Permit No.	Date	Document ID No.
44-01	January 15, 2010	9332

Subject: Clarification, Additional Information, and Response to
December 23, 2009 Engineering Review / Completeness Letter
Haywood County, Permit #44-01, Document ID No. 9091

Continuous Methane Monitoring Alarm Procedure Closed International Paper Company Landfill 5 #44-01 Haywood County, North Carolina January 12, 2010

DATE: 11/18/09
DRAWN BY: ALH
CHECKED BY: JAC
PROJECT NO. 09040402
SHEET NO. C-4

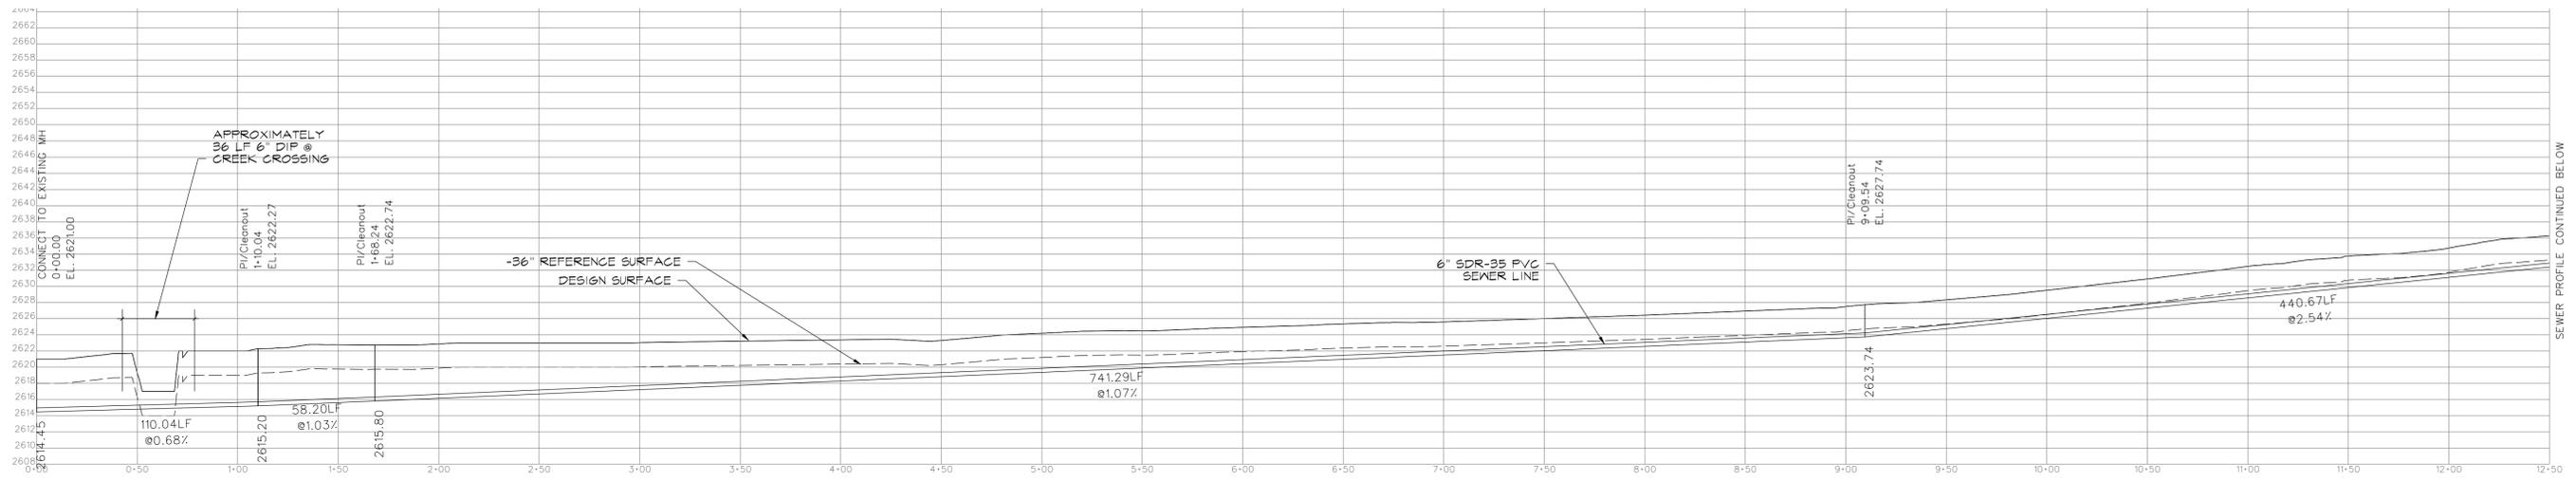
"3. Please provide copies of Sheet Numbers C-6 and C-7 which were not complete at the time of the original application submittal."

Sheets C-4 through C-7 have been completed and submitted for DENR approval to Mr. Don Price in the Asheville Regional Office. Current versions of the sheets are attached for your reference.

YARD INLET

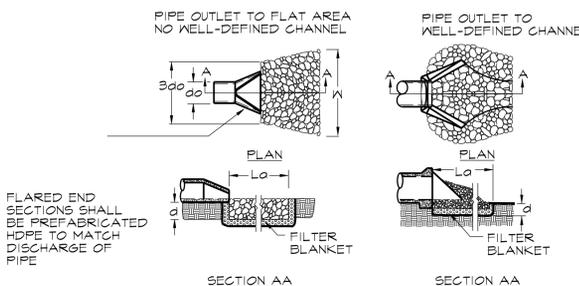
"4. Is the Yard Inlet detailed on Sheet Number C-10 the same feature as the Concrete Open Throat Catch Basin Called out on Sheet Number C-3."

Yes, both the detail and the reference on Sheet C-3 were revised following receipt of comments during the bidding process for construction of the project. Sheet C-10 is attached.

FIGURE
1

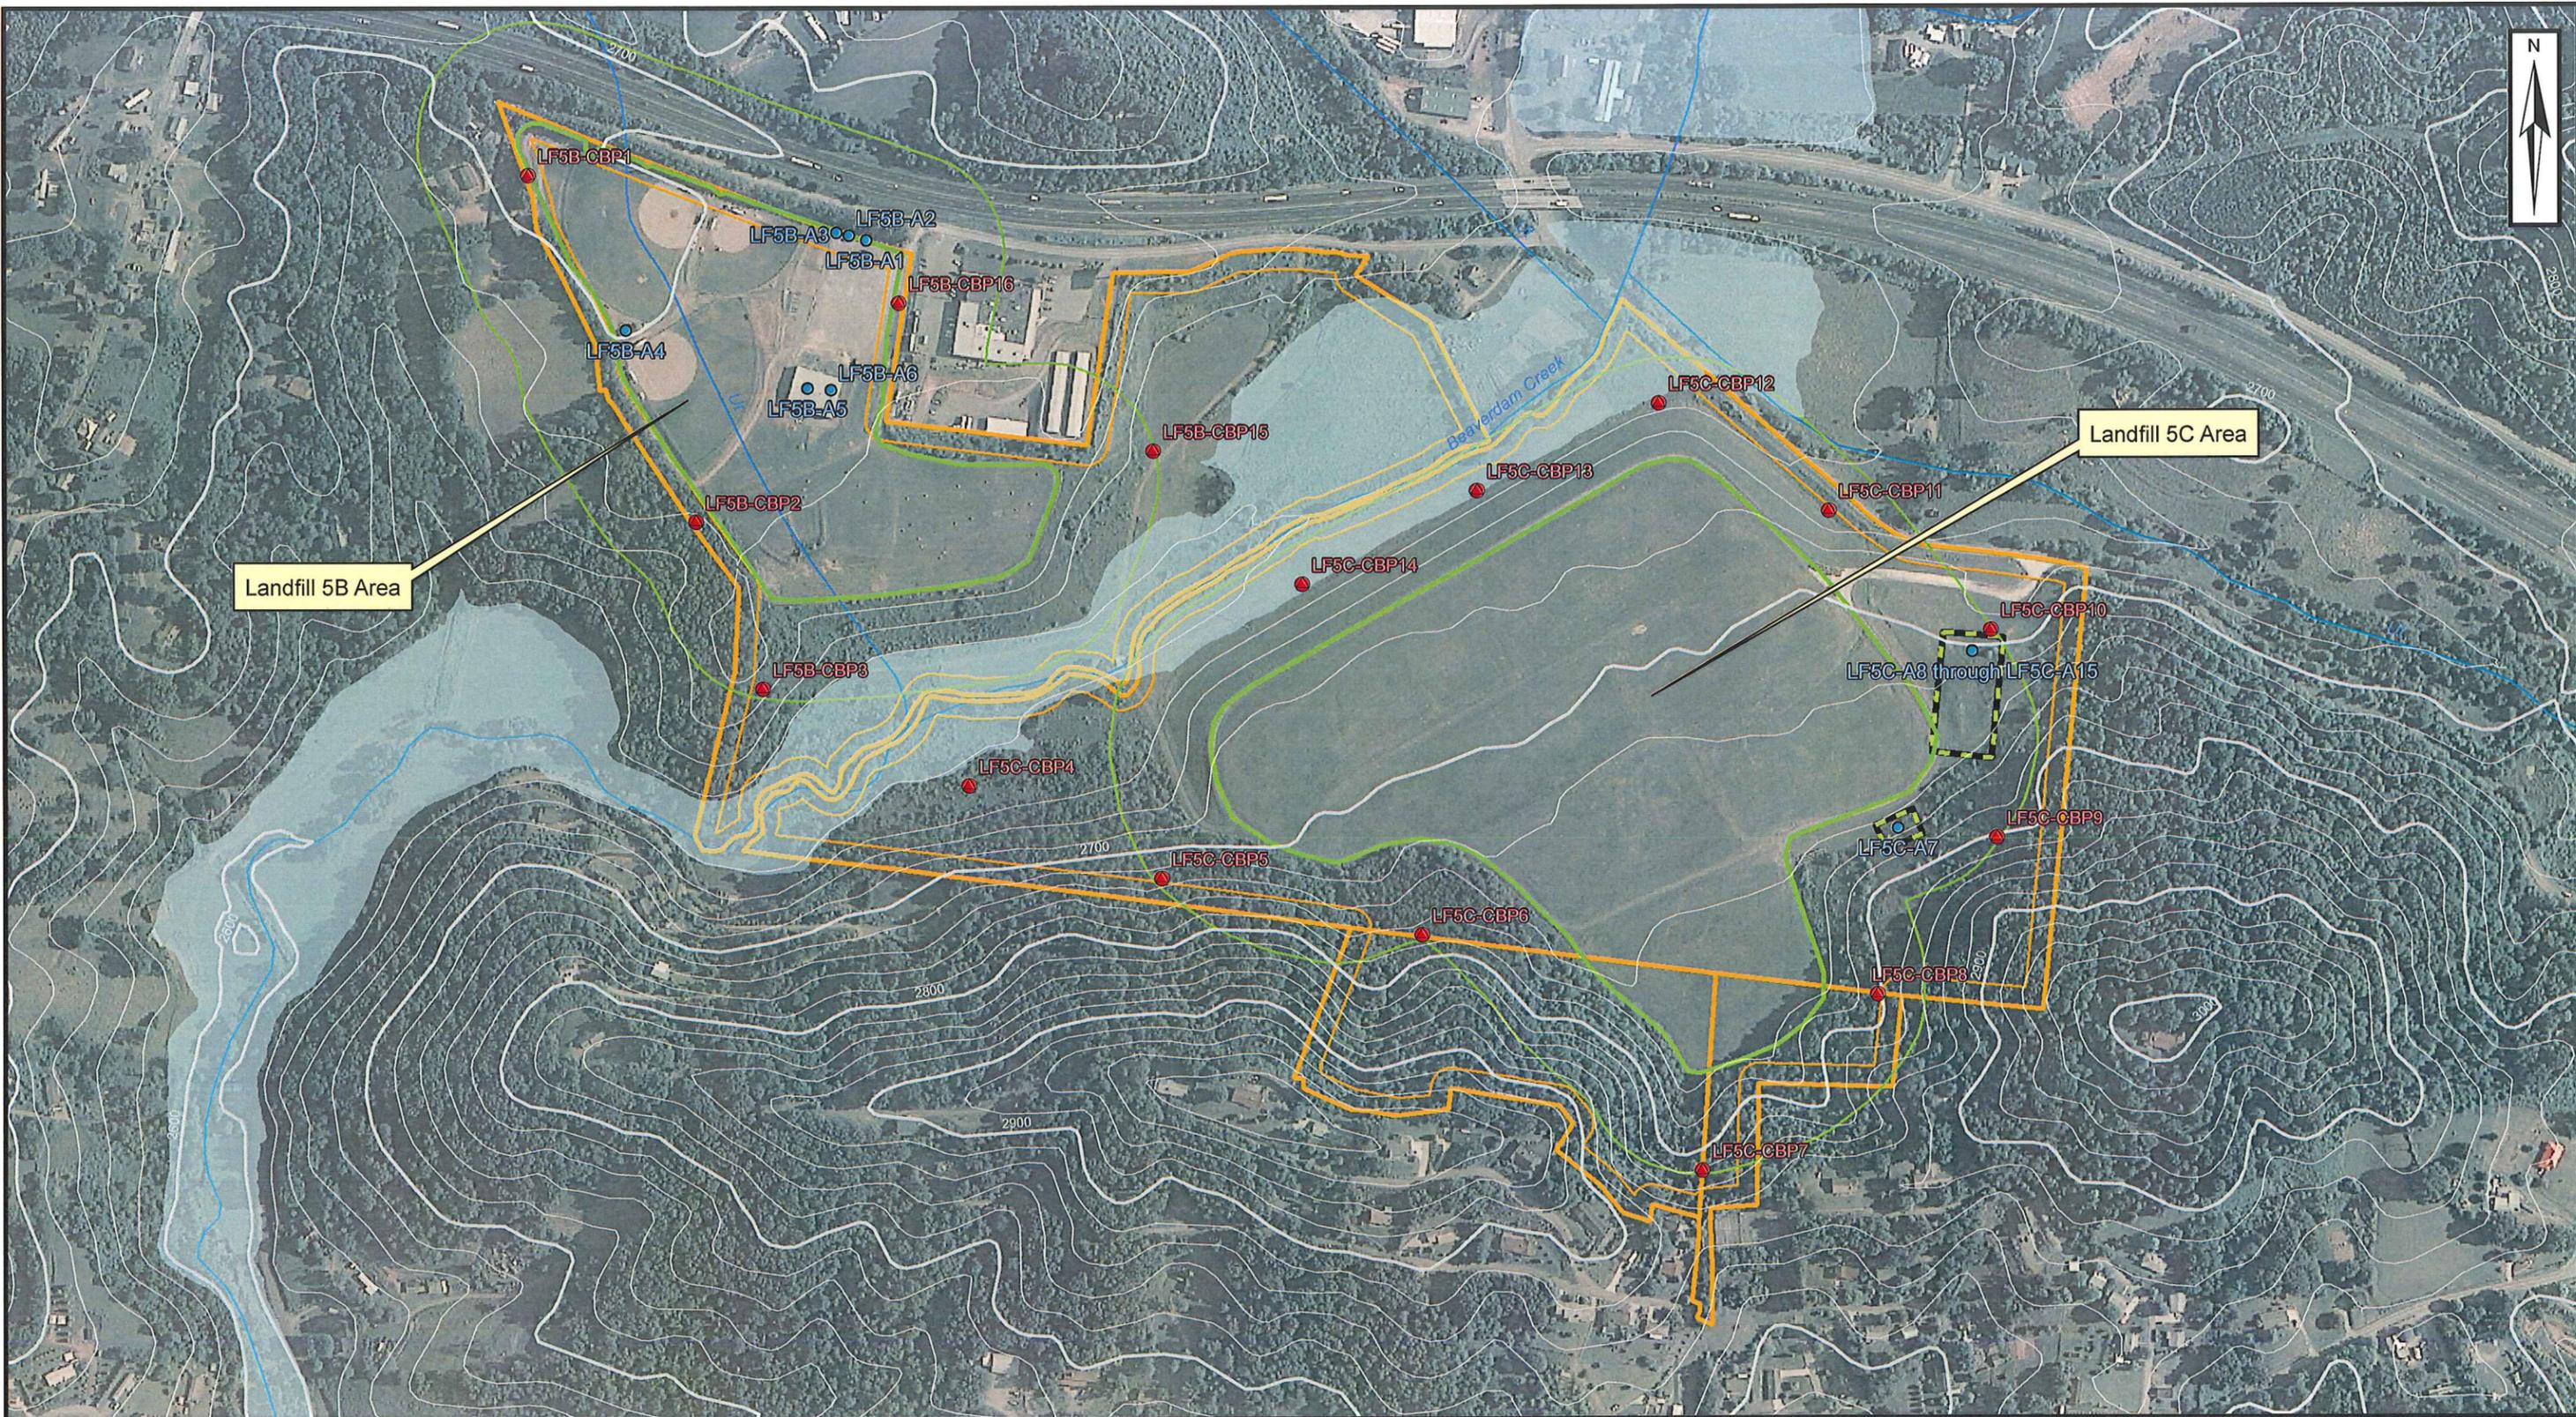
"6. Please verify landfill gas probe location LFB-A1, A2 and A3 on Figure 1 – Landfill Gas Monitoring Well Locations are the actual locations of the Football Storage Building, Little League T-Ball Storage Building and Maintenance Office.

Locations LFB-A1, A2 and A3 on Figure 1 of the Landfill Gas Monitoring Plan, submitted to the Solid Waste Section on December 10, 2009, are quarterly ambient screening locations and are not landfill gas probes. Samples are obtained from these locations using a Landtec GEM 2000 Gas Analyzer and Extraction Monitor. These screening locations are inside the referenced buildings which are accurately displayed on the attached Figure 1.
